NO.	DATE	DESCRIPTION	BY	APP.
1	7/1/19	PCO #36 STREETLIGHT SERVICE	ST	SL

2ND STREET STREETSCAPE IMPROVEMENTS PROJECT

STREET LIGHTING PLAN
2ND STREET
TOWNSEND STREET TO KING STREET

CONTRACT NO. 1064J
DRAWING NO. E-5.0
FILE NO. 106,290
REV. NO. 1

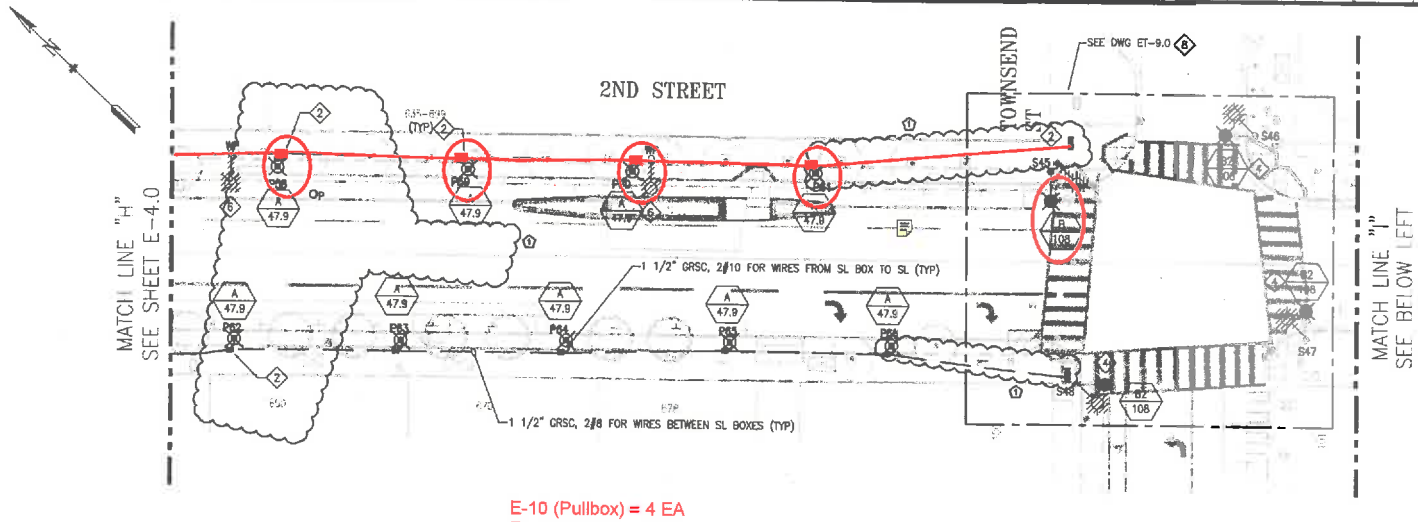
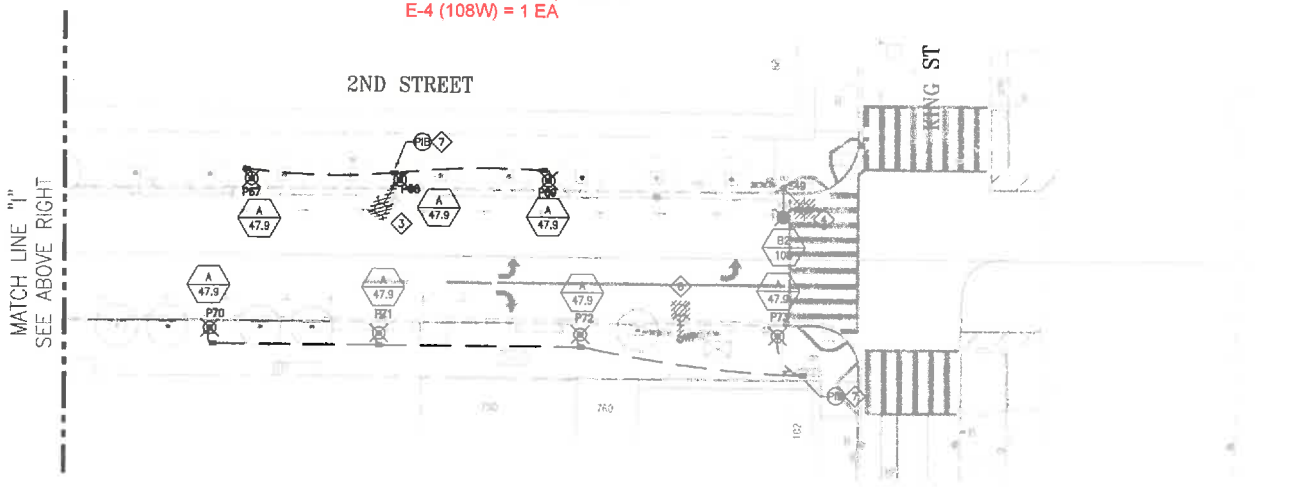
E-10 (Pullbox) = 4 EA
E-13 (1.5" Conduit) = 330 ft
E-4 (108W) = 1 EA

1. PROVIDE 40A FUSE FOR STREETLIGHT CIRCUIT AND CONNECT (N) SL CIRCUIT TO THE (E) SL CIRCUIT. SEE SPDPWSF #87.203 FOR WIRING DIAGRAM AND 87.204 FOR WIRES' SPLICING DETAIL AND REQUIREMENT, UON.
2. PROVIDE 10A FUSE FOR STREETLIGHT, UON.
3. R/S (E) SL POLE AND R/C POLE FOUNDATION 3' BELOW GRADE.
4. DISCONNECT (E) SL CIRCUIT. REMOVE AND REPLACE (E) FIXTURE WITH NEW, TYPE AS SHOWN. RECONNECT TO (E) CIRCUITS.
5. REPLACE (E) FIXTURE WITH NEW FIXTURE, TYPE AS SHOWN. PAINT, REFURBISH (E) SL POLE AND ARM.
6. TO BE DEMOLISHED BY PG&E. CONTRACTOR TO NOTIFY PG&E VIA SFPUC-BLHP AFTER STREETSCAPE LIGHTING IN PROJECT AREA IS ACCEPTED BY SFPUC-BLHP.
7. SPLICE TO EXISTING SL CIRCUIT.
8. REFER TO ET SERIES DWG FOR SL CIRCUIT CONNECTION.
